CITY OF SAN ANTONIO

Re: Alamo Ranch Subdivision (Amending) MDP # 808-A

The City Staff Development Review Committee has reviewed **Alamo Ranch Subdivision (Amending).** Master Development Plan M.D.P. # 808-A. Please find enclosed a signed copy for your files. Your plan was accepted, however please note the following:

ALAMO RANCH
1,693.0 ACRE TRACT
MASTER DEVELOPMENT PLAN

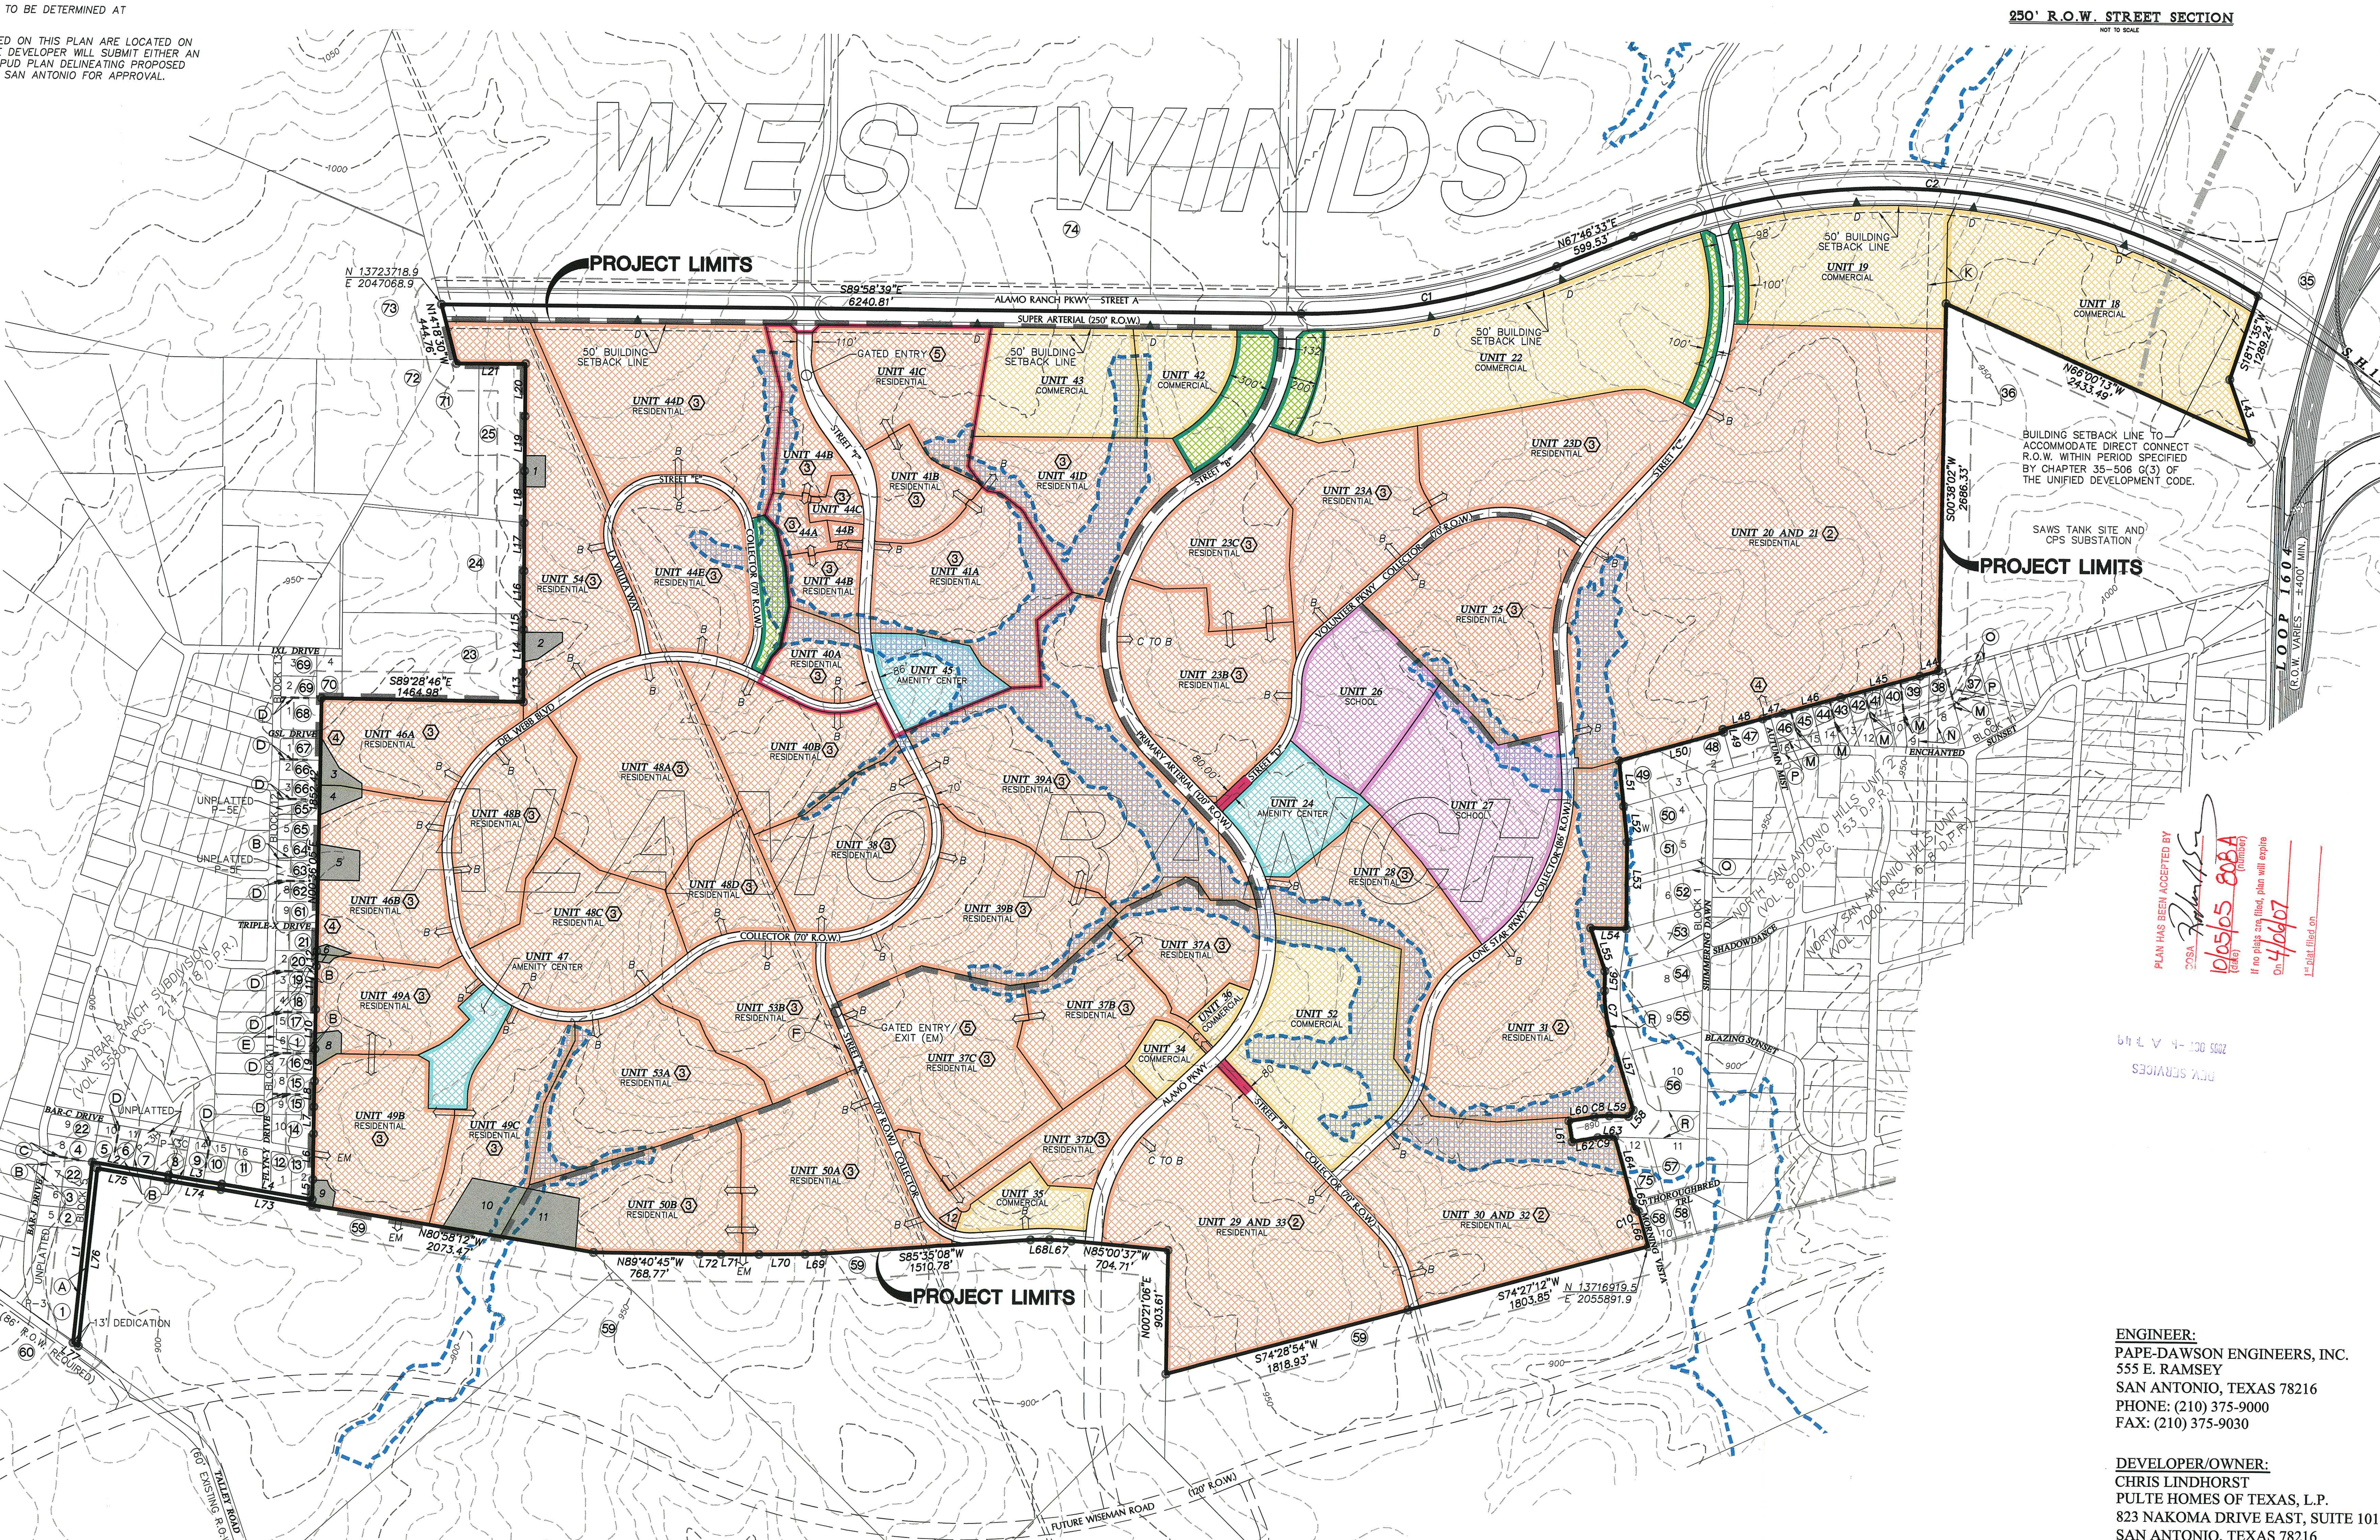
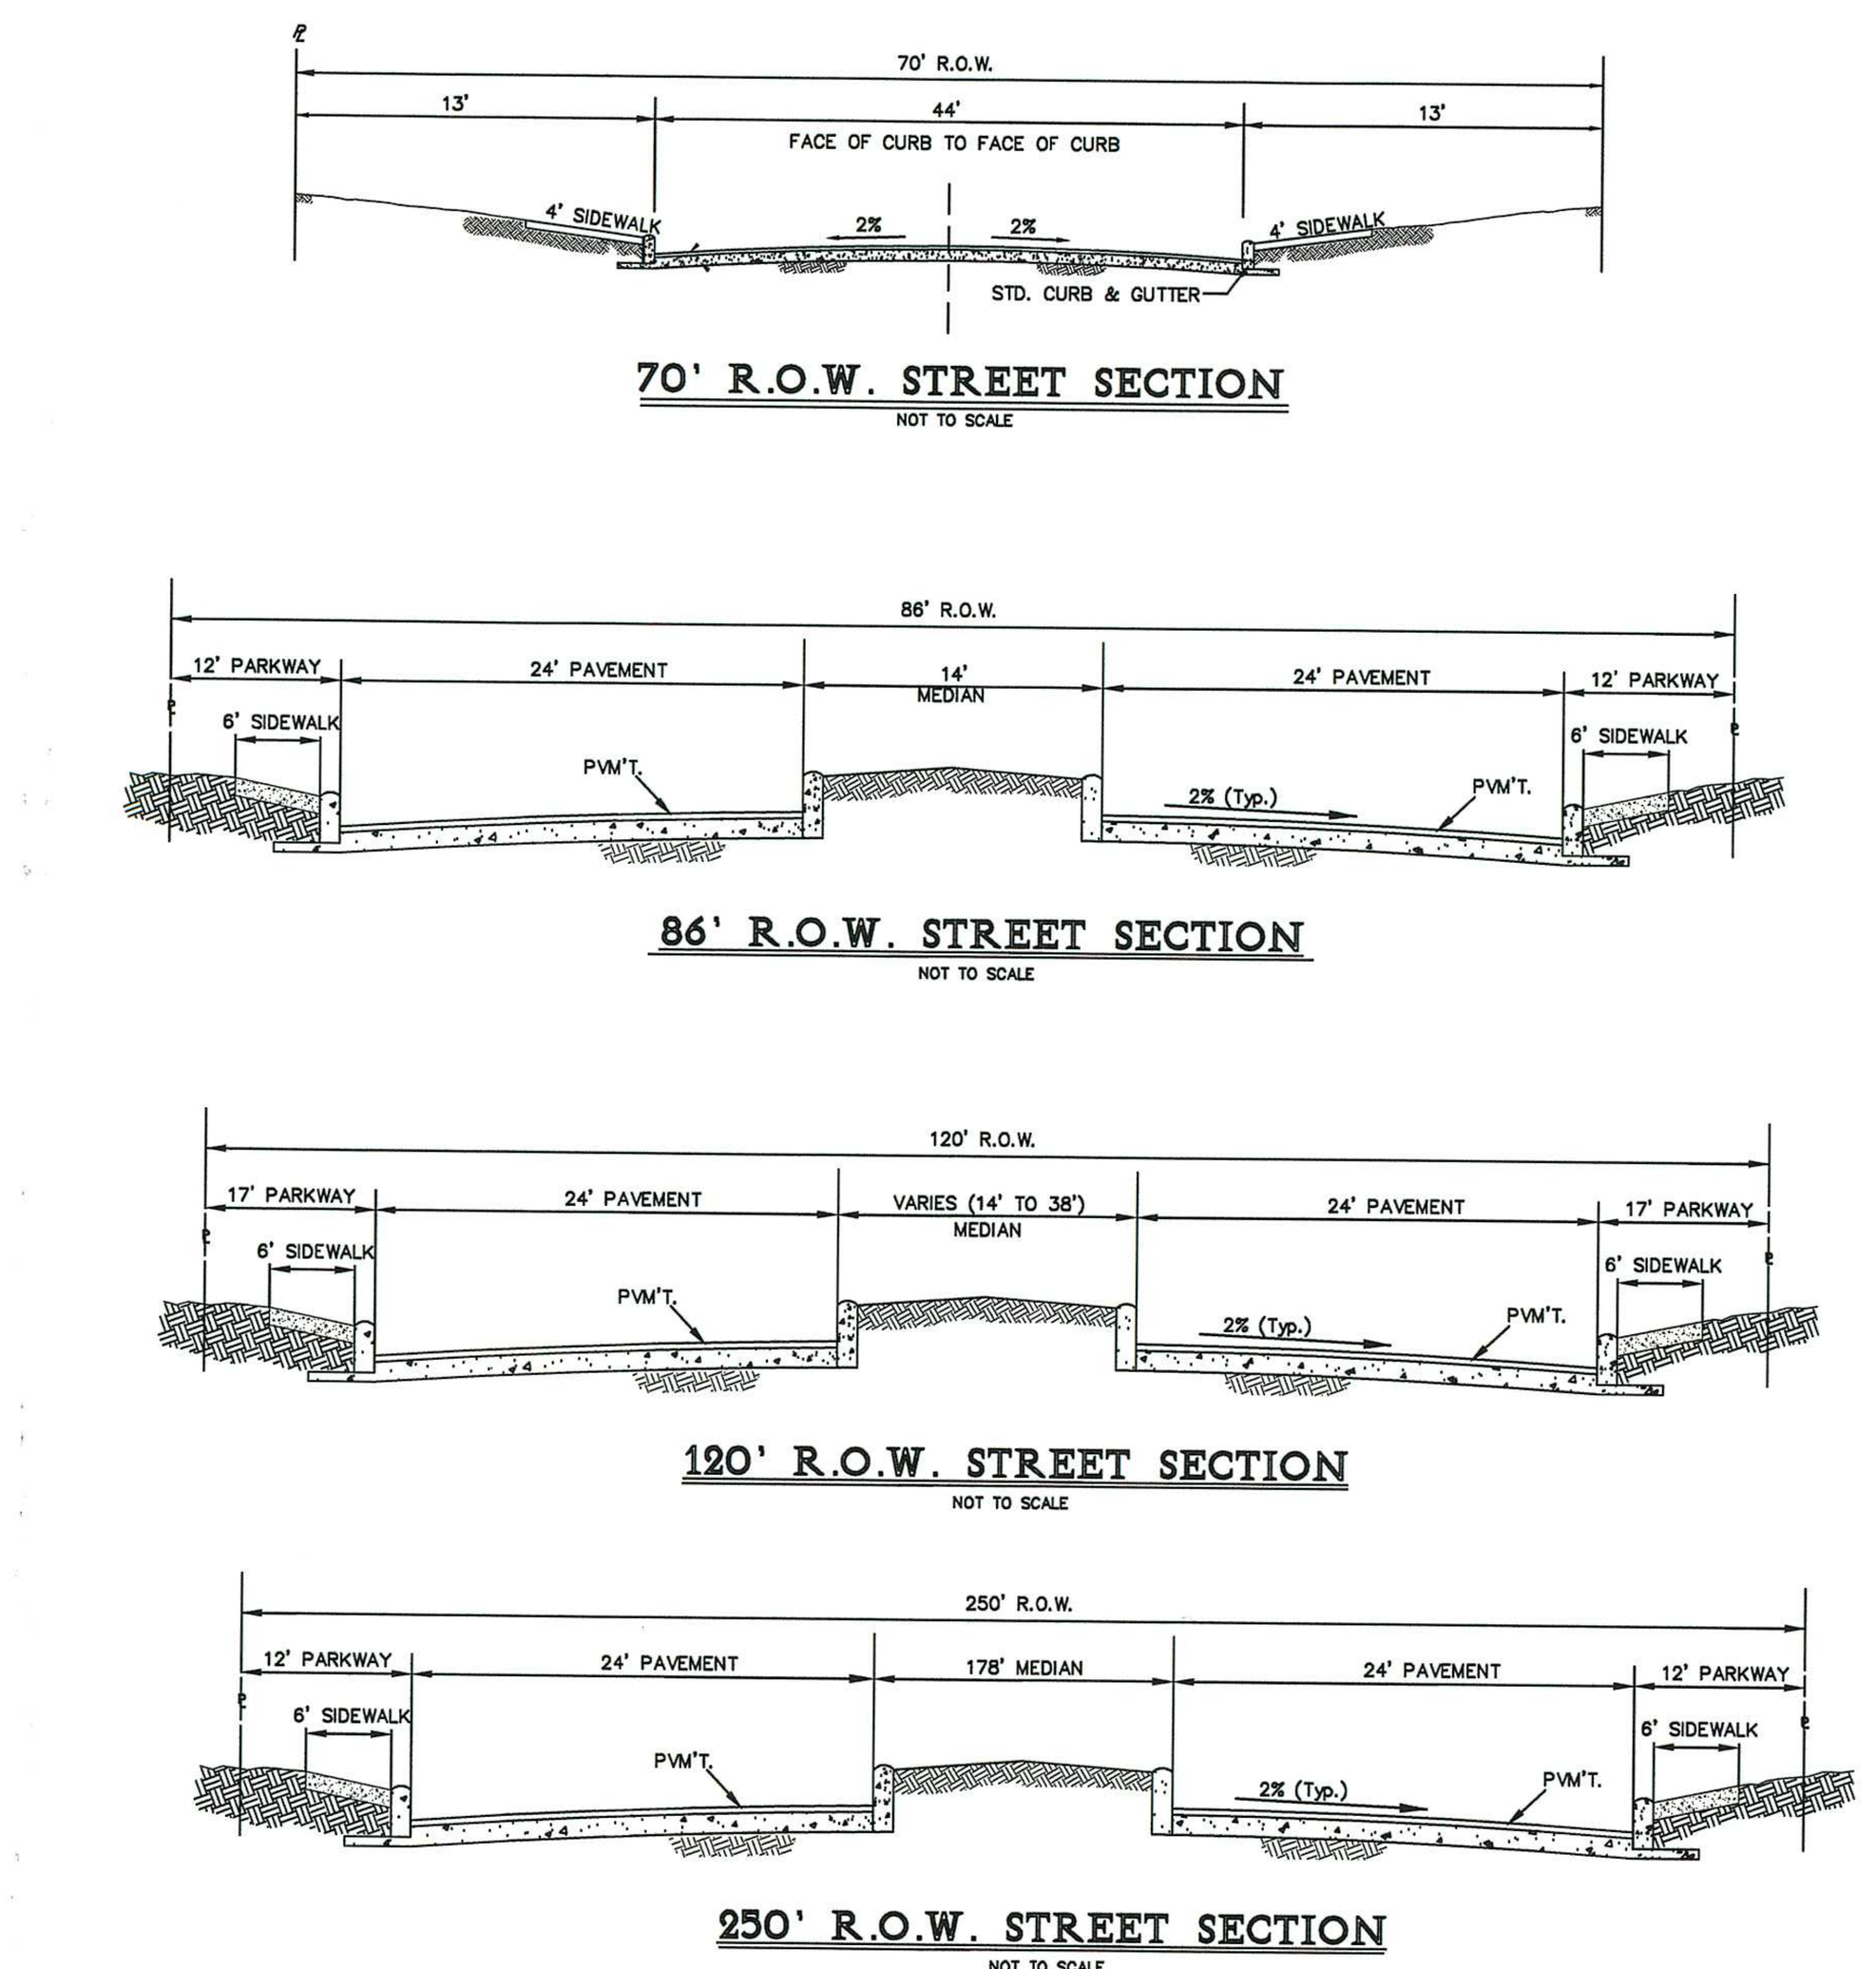
- In consideration of public safety and convenience, excessive grades by reason of topography should be avoided in street layouts and arrangements.

- Any access and R.O.W. issues along state facilities will need to be resolved with the **Texas Department of Transportation (TXDOT)**. For information about these requirements you can contact TXDOT at 615-5814.

All roadways shall follow Table 506-7, Functional Classification System Description and shall comply with UDC 35-502(a)(9). All access roadways shall provide clear sight distance on all existing and proposed roadways in order to provide adequate obstruction free viewing distances for approaching traffic. All signage, landscaping, and improvements shall be selected and located so as to not block these clear sight distance areas.

All streets and driveways shall follow UDC 35-506 and the street network shall be planned in order to provide safe and efficient movement of traffic to and from, within and past, the proposed development, while minimizing the impact to non-site trips. UDC 35-506 will be implemented at the time of platting.

1. For Units 20/21, 30/32, 29/33, and 31, park fees or park plans be submitted with each individual plat as stated in formal letter.
2. For Units 23(A-D), 25, 28, 37(A-D), and 50(A-B) a detailed list of amenities will be provided for the amenity center in Unit 24 at time of platting as stated in formal letter.

3. Unit 24 be platted by second phase for Units 23(A-D), 25, 28, 37(A-D), and 50(A-B) per UDC Section 35-503(f)(2) to fulfill park/open space requirements.

4. For Units 38, 39(A-B), 40(A-B), 41(A-D), 44(A-E), 46(A-B), 48(A-D), 49(A-C), 53(A-B), and 54 within the Del Webb community a detailed list of amenities will be provided for the amenity center in Units 45 and 47 at time of platting as stated in formal letter

5. Units 45 and/or 47 be platted by second phase for Units 38, 39(A-B), 40(A-B), 41(A-D), 44(A-E), 46(A-B), 48(A-D), 49(A-C), 53(A-B), and 54 per UDC Section 35-503(f)(2) to fulfill park/open space requirements.

- Alamo Ranch Parkway (SH 151) is not designated as a state highway west of Loop 1604, however it will be extended west of Loop 1604 as a four lane divided Super Arterial with a minimum of 250 feet right-of-way.

- Alamo Parkway is classified as a primary arterial with 120 feet right-of-way, and will be extended through this development as a four lane divided roadway.

- Street F will be a loop road within the senior adult community, and will be constructed as a four lane divided roadway with turn lanes provided at all internal intersections.

- The primary gated entry of Street F shall provide for appropriate queue storage and turn around capacity for the full build out of the senior adult community. If queuing at the main entrance interferes with the public roadway system, then Bexar County reserves the right to require appropriate action to eradicate the problem.

- Roadway configurations adjacent to and within the Alamo Ranch Subdivision shall be consistent with Table 14 of the Seale Ranch Level Three Traffic Impact Analysis prepared September 2004.

- Traffic controls shall be warranted as per the Texas Manual on Unified Control Devices and approved by TxDOT and / or Bexar County.

It is understood that this MDP is a conceptual plan and controlled access should be maintained in order to uphold safe and efficient traffic flow. Therefore, the developer of this property is encouraged to design common access and shared driveways between all proposed commercial lots. Bexar County reserves the right to address driveways, street design, sight distance, ADA requirements, drainage and floodplain issues at time of platting.
